# SB1 Guideline Document Comments

By  
Willard MacDonald  
Solmetric Corporation  
[Willard@solmetric.com](mailto:Willard@solmetric.com)

<b>DOCKET</b>	
<b>07-SB-1</b>	
DATE	OCT 01 2008
RECD.	OCT 07 2008

I would like to make the following comments on the "Guidelines for California's Solar Electric Incentive Programs Pursuant to Senate Bill 1 -- Second Edition". My comments are regarding sections of Appendix 2.

Figure 5 – The Minimal Shading Criterion - Artistic Depiction of “H” and “D”

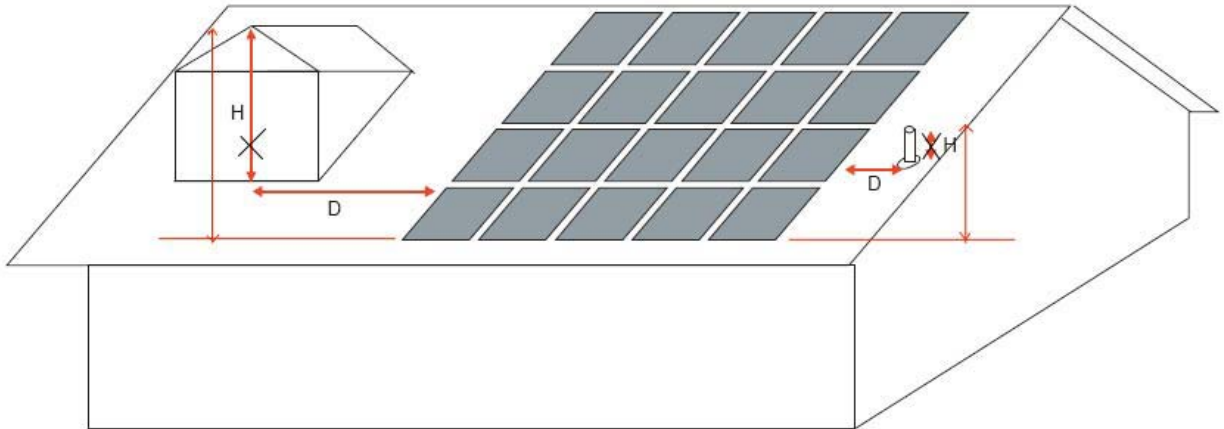
There is a discrepancy in the SB1 requirements document on page 55 and 56 regarding minimal shading. For the definition of H, the text reads

"Any obstruction that projects above any portion of the PV array must meet this criterion for the PV array to be considered minimally shaded."

"It is the responsibility of the PV installer and the verifier to determine the worst condition by determining the point on the array and the point on the obstruction that would result in the smallest ratio"

"Generally, the portion of the array that will most likely be shaded and thus represents the worst condition is the lower corner of the array"

However, the figure 5 shows something different than what these three texts state. In the figure, the height of the dormer obstruction is shown as the height above the array at the point where the second row of modules starts and the height of the pipe is shown as the height above the point in the middle of row 2. Based on the text, they should both be shown as the height above the bottom edge of the array since this would be the height "above any portion of the PV array". This would give the "smallest ratio" and also more accurately reflects the fact that shading from the dormer or pipe can impact the modules in the bottom row. Since most people will pay more attention to the figure, than the text, I suggest it be corrected.

I suggest changing figure 5 as shown in the figure below to clear this up:

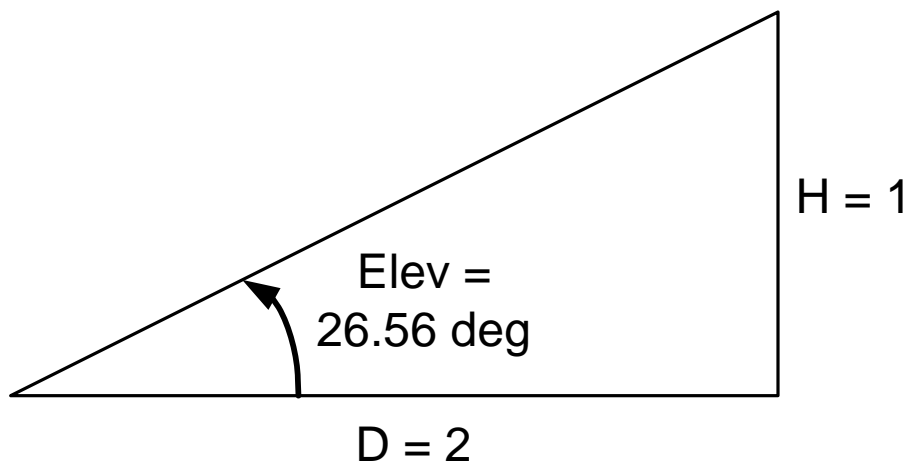
“The “minimal shading” criterion is that no obstruction is closer than a distance (“D”) of twice the height (“H”) it extends above the PV array (see Figure 5 for an artistic depiction of “H” and “D”). “

This defines minimal shading as a D to H ratio of 2:1. It should also mention that the equivalent altitude angle to the 2:1 ratio is 26.56 degrees. This is demonstrated in the figure below and by the equation  $\text{ARCTAN}(1/2) = 26.56$  degrees.

It should be made clear that having an angle less than 26.56 degrees also qualifies for minimal shading. The angle measurement should be made from the location giving the largest angle

which is usually the lowest point on the array closest to the obstruction (the same location where the H distance is measured from).
